Technical Assessments in Support of the Edwards Aquifer Science Committee “J Charge” Flow Regime Evaluation for the Comal and San Marcos River Systems

The Edwards Aquifer Recovery and Implementation Program

**Dr. Thomas B. Hardy, Ph.D.
River Systems Institute
Texas State University
San Marcos, Texas**

December 29, 2009

Figure 1. Comal River study area.

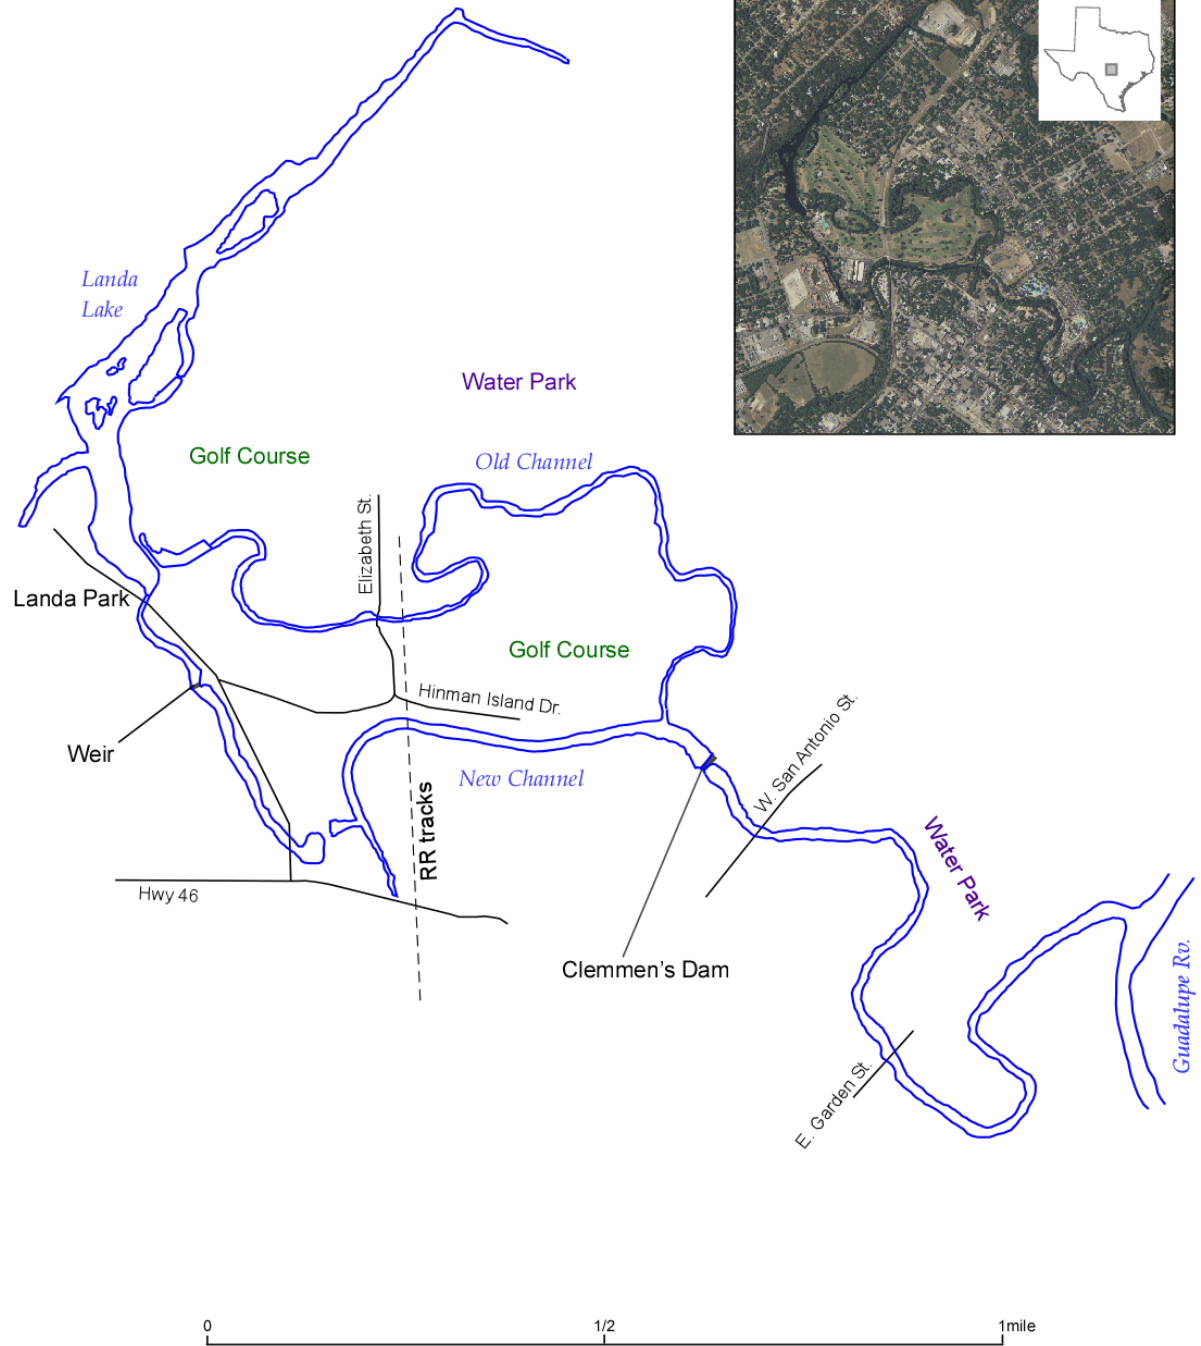
<p>Figure 1 on page 13 is mislabeled as a map of the San Marcos system, but the map is of the Comal system. A notation in the text indicates that Figure 1 will be updated to reflect the style in Figure 2. During this update process, the caption label should be corrected.</p>	<p>Fixed.</p>
	<p>On pages 16 and 19, the report states that additional components to the influence diagram will need to be developed to evaluate the effects of possible HCP actions on Comal Springs riffle-beetle, Texas Wild-rice, and Fountain Darers. Would the authors undertake this process of expanding upon the initial Influence Diagrams, or would the process of expanding upon the Influence Diagrams include all interested EARIP stakeholders?</p>	<p>This would be undertaken as part of the HCP process as the USFWS works on issues related to the BiOp. I will be part of this process as can the stakeholders.</p>
	<p>The portion of the report that focuses on "Development of Computational Meshes" on page 23 discusses examples of varied interpolation algorithms or gridding procedures to create the Most Representative Surface (MRS). Was the same interpolation method used in both river systems? Did each of the river segments evaluated in both systems use the same interpolation algorithms, or were there differences between systems and within each system between reaches? A notation is given in the last sentence for finding the details of the methods used; however, an expanded, yet still generalized, discussion of the type(s) of gridding procedures by system and by reach might be helpful.</p>	<p>The same gridding algorithm (natural neighbor) was used for both systems and all sections. This has been added to the text for clarification.</p>

Figure 6. Example of potential human influences on water quantity and quality for the Comal Springs riffle beetle.

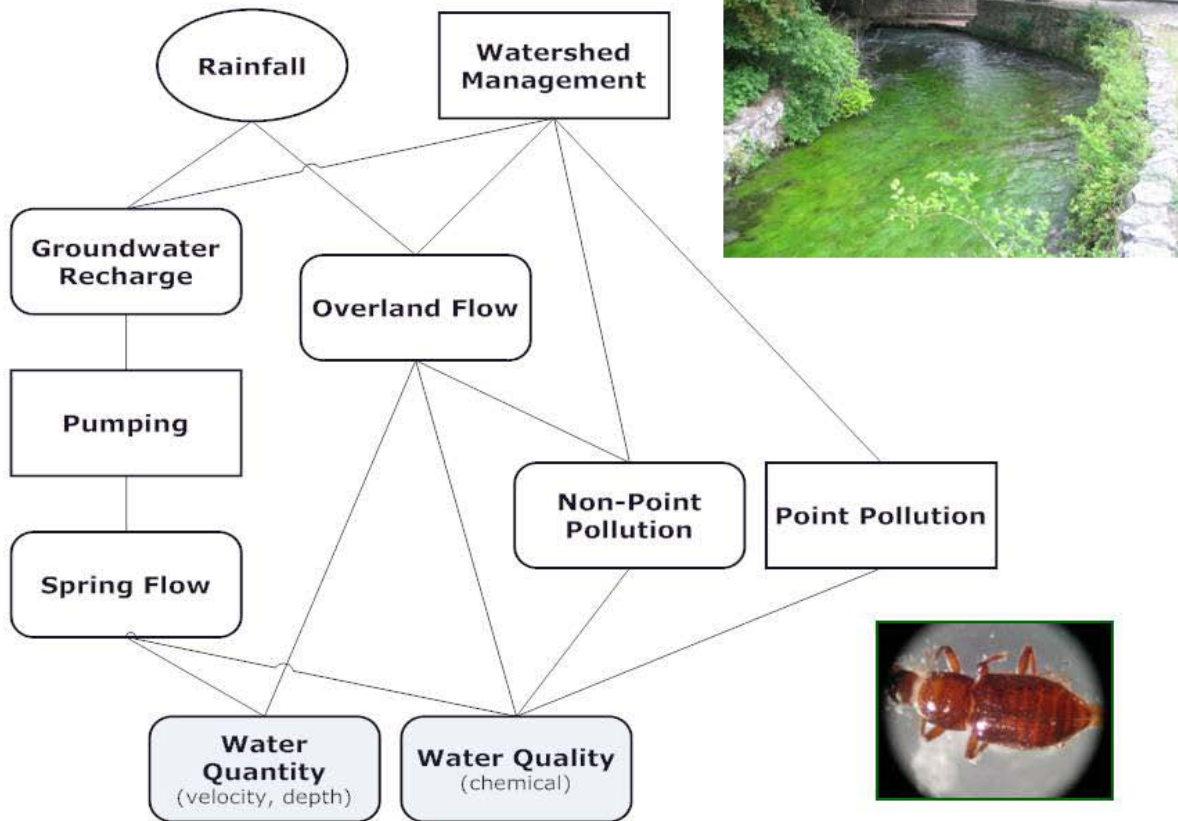
Figure 6 - No Comal Springs riffle beetles have ever been found at your picture of Spring run 5 at Comal.	Updated with the picture you sent.
	No real discussion of the influence diagrams or summary paragraph to say what they were or will be used for. See next point.	Text was added to clarify the purpose of the diagrams, what their intent is, and how the modeling 'connects' to them.

Figure 26. Texas wild rice depth habitat suitability. See text for explanation of curve legends.

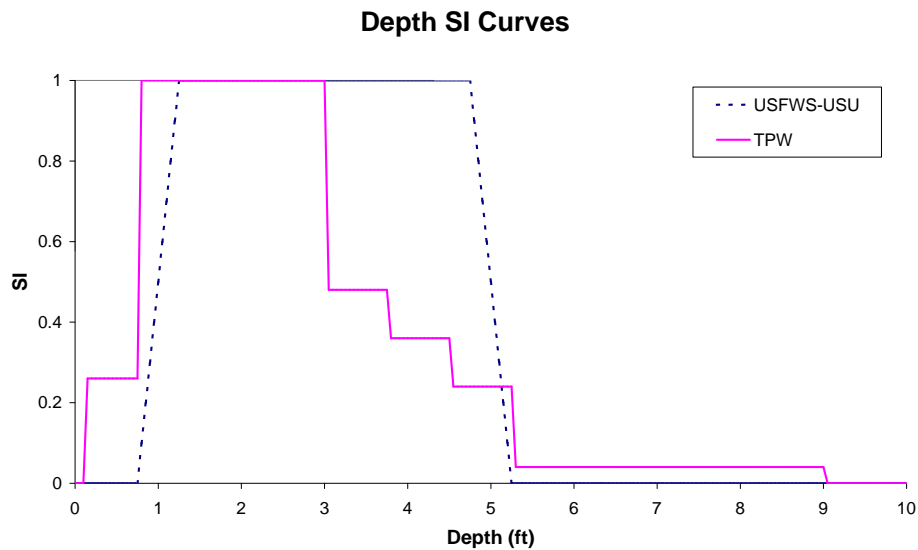
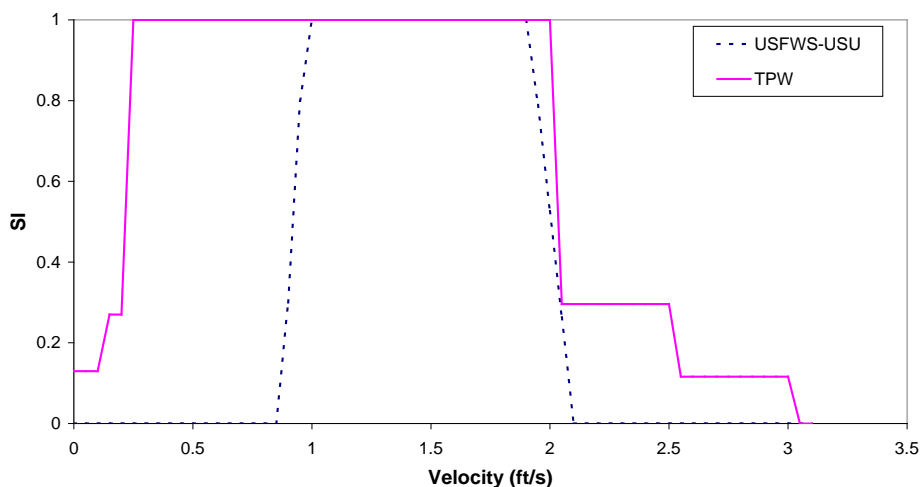
Page 45: Figure 26, although labeled as depth habitat suitability, appears to be a duplicate of Figure 27 and a depiction of the velocity habitat suitability curve.	Updated the correct Figure.
	Page 57: I found the last paragraph in the Dissolved Oxygen section to be a bit difficult to follow. Would it be possible to expand a bit on the discussion of the diel DO swings? In particular, it is unclear if the observed field values of DO include 24-hour monitoring. At any rate, some expanded discussion, if possible, of the diel swings would be helpful	Expanded the discussion on implications of diel oxygen swings. See page 41 where it states that the diel model calibration and validation runs were based on measured hourly data sets.

Figure 39. Depth and velocity contour plots at 10 and 40 cfs in the Upper Old Channel section of the Comal River. Color legends are scaled between 0.0 (red) and the maximum indicated (blue) in 10 increments of the maximum magnitude indicated.

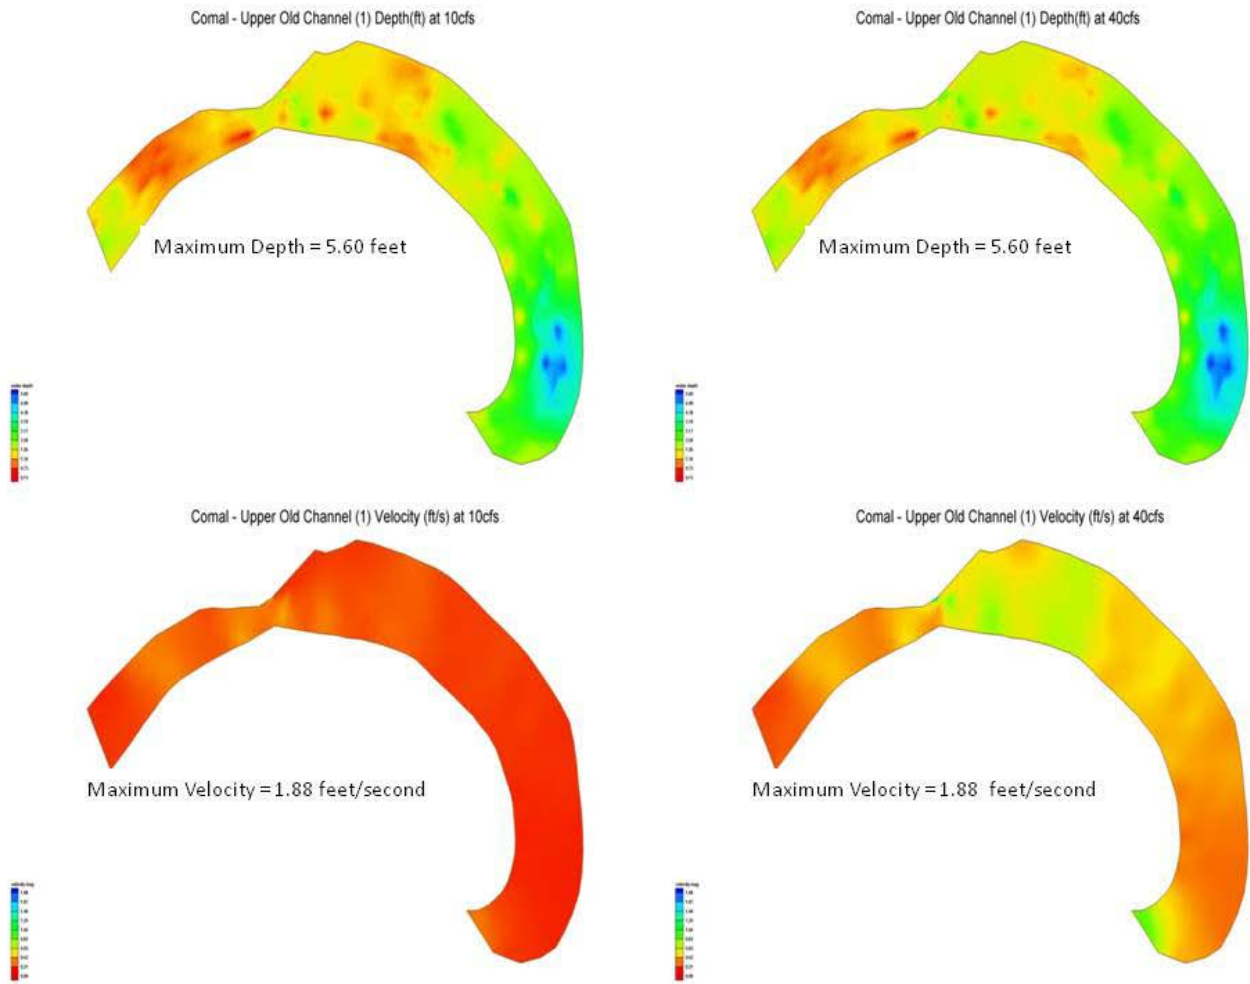
p. 61, Fig. 39 - The plots for depth for 10 & 40 cfs look identical. Are they or does one need to be replaced?	Revised the scaling for these figures, changed to larger plots for readability.

Figure 43. Major simulation reaches utilized by Bartsch et al. (2000).

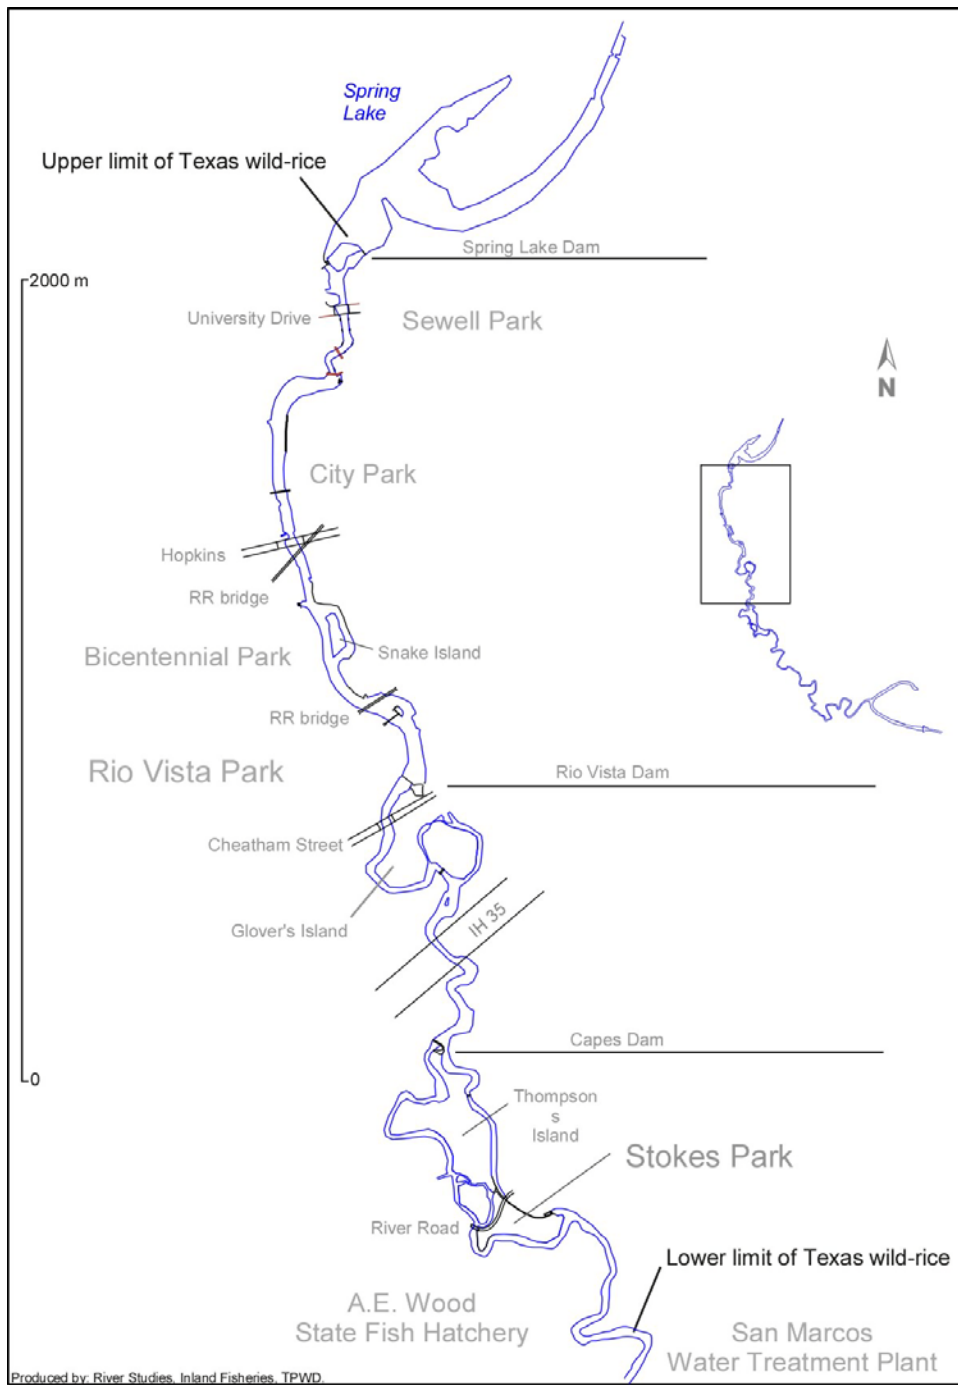
p. 66, Fig. 43 - This figure is very difficult to read; plus are the simulation reaches in black or brown?	Revised this figure to make it readable .
	p.67, Table 12 - This table shows that WUA increases steadily with increasing flows in Rio Vista and Above Cape's Dam. When is this data from? Why does it differ significantly from Table 13?	Text was clarified in terms of source of data and modeling. Table 12 was based on suitability curves used in Bartsch et al. 2000 and are different than the TPWD curves used in the current analysis.
